LEXINGTON-FAYETTE URBAN COUNTY GOVERNMENT CONTRACT CHANGE ORDER Page 1 of 2	Date:	April 27, 2016
	Project:	Senior Citizen Center Constructio
	Location:	Lexington
To (Contractor): Marrillia Design & Construction 259 West Short Street Suite 325 Lexington, KY 40507	Contract No.	227-2014
	Original Contract Amt.	\$8,882,900.00
	Cumulative Amount of Previous Change Orders	\$1,452,952.37
	Percent Change - Previous Change Orders	16.36%
	Total Contract Amount Prior to this Change Order	\$10,335,852.37
	Change-Order No.	42

JUSTIFICATION FOR CHANGE

PROJECT	LFUCG Senior Citizens' Center 201333	DATE SENT	4/21/2016
SUBJECT	Light Fixture at Monument Sign	PROPOSAL REQUEST ID	PR-074
TYPE	Proposal Request	TRANSMITTAL ID	00965
PURPOSE	For Review and Response	VIA	Info Exchange

PROJECT	LFUCG Senior Citizens' Center 201333	DATE SENT	4/21/2016
SUBJECT	Credit for Wood Platform Stairs	PROPOSAL REQUEST ID	PR-075
TYPE	Proposal Request	TRANSMITTAL ID	00967
PURPOSE	For Review and Response	VIA	Info Exchange

PR-074

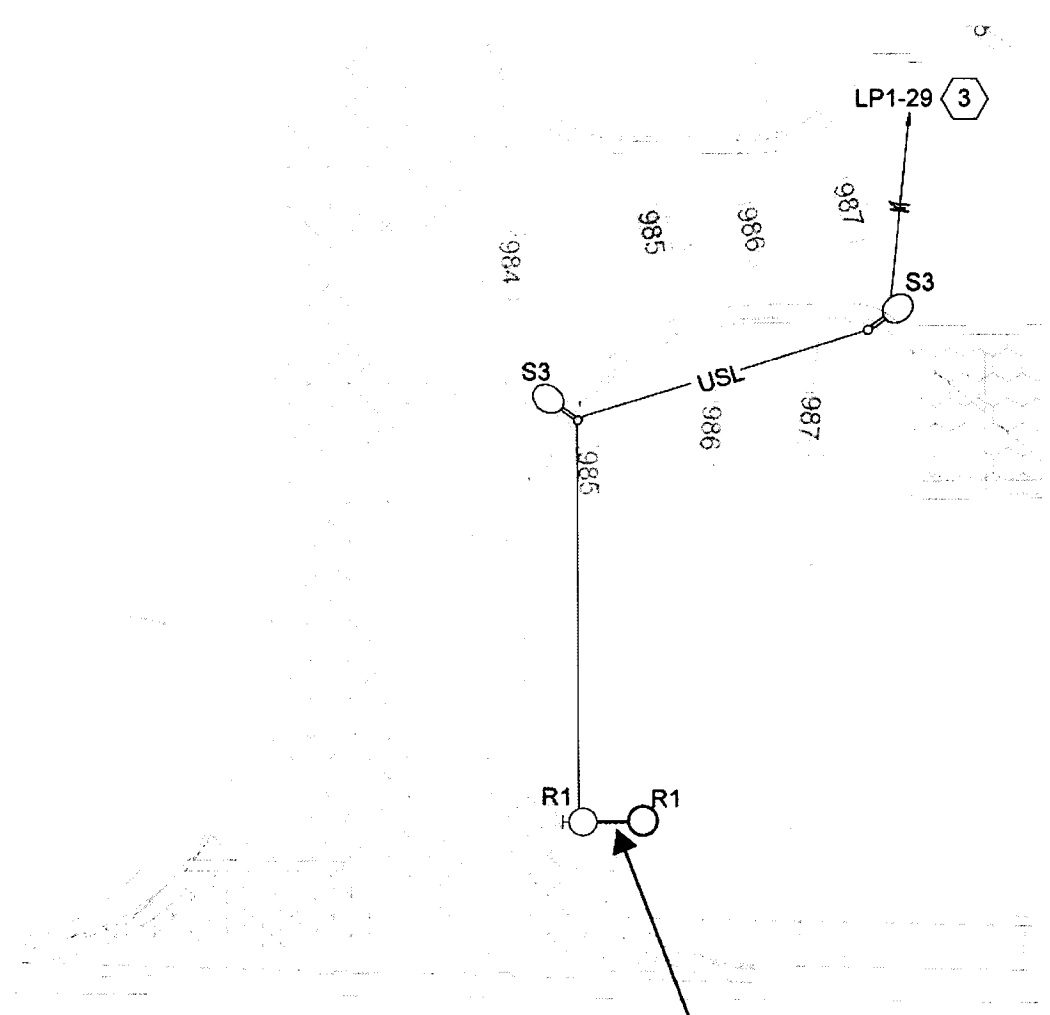
Please provide pricing to add (1) R1 ground-mounted flood fixture at the street entry monument sign. Fixture to be located and wired per the attached sketch. Architect/engineer shall verify the distance from the light fixture head to the sign face.

ADD (1) R1 GROUND MOUNTED FLOOD LIGHT FIXTURE. CONNECT TO LP1-29 CIRCUIT. POSITION CENTERED ON THE MONUMENT SIGN. ARCHITECT TO VERIFY DISTANCE FROM SIGN FACE.

SKA-117

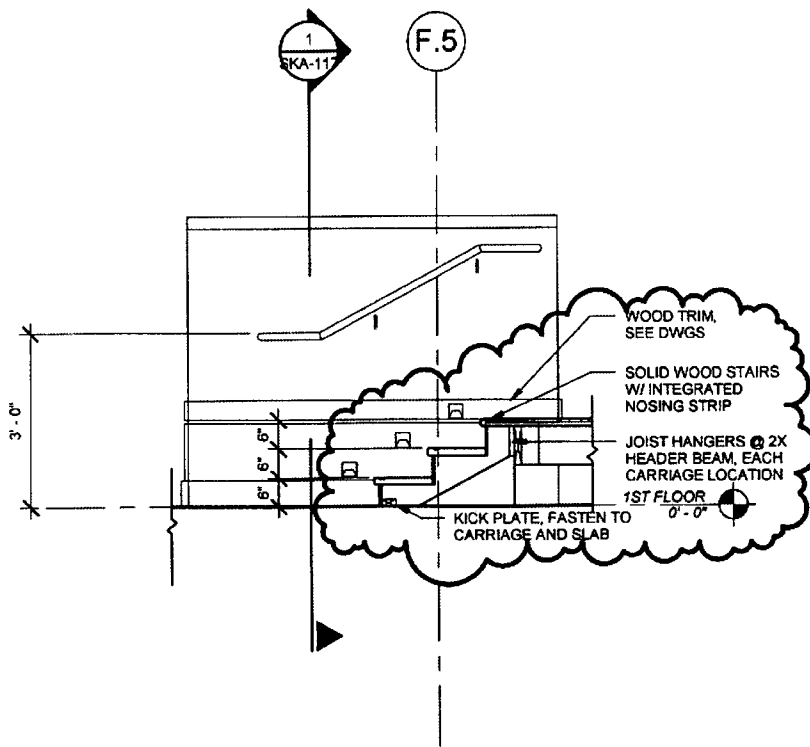
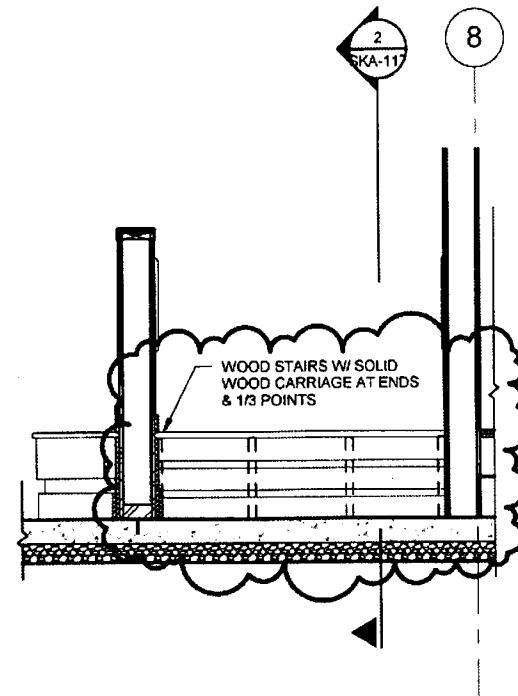
Per RFI-158, the platform stair structure was allowed to be wood in lieu of concrete-filled steel pans and stringers. Please prepare offsetting credits for this change, including material and labor costs.

QUESTION:
SUGGESTION:

ANSWER: Hi Travis,
It will be acceptable to frame these stairs in wood. Please follow the AF&PA standards for construction, and provide fire-treated framing throughout. See attached sketch SKA-117 for design intent. I'm happy to meet with the Bennett's team to discuss alternative methods. Field verify all dimensions. Let's discuss credit pricing for the difference between concrete/steel pan stairs and revised wood stair construction.
Thanks,
Harding
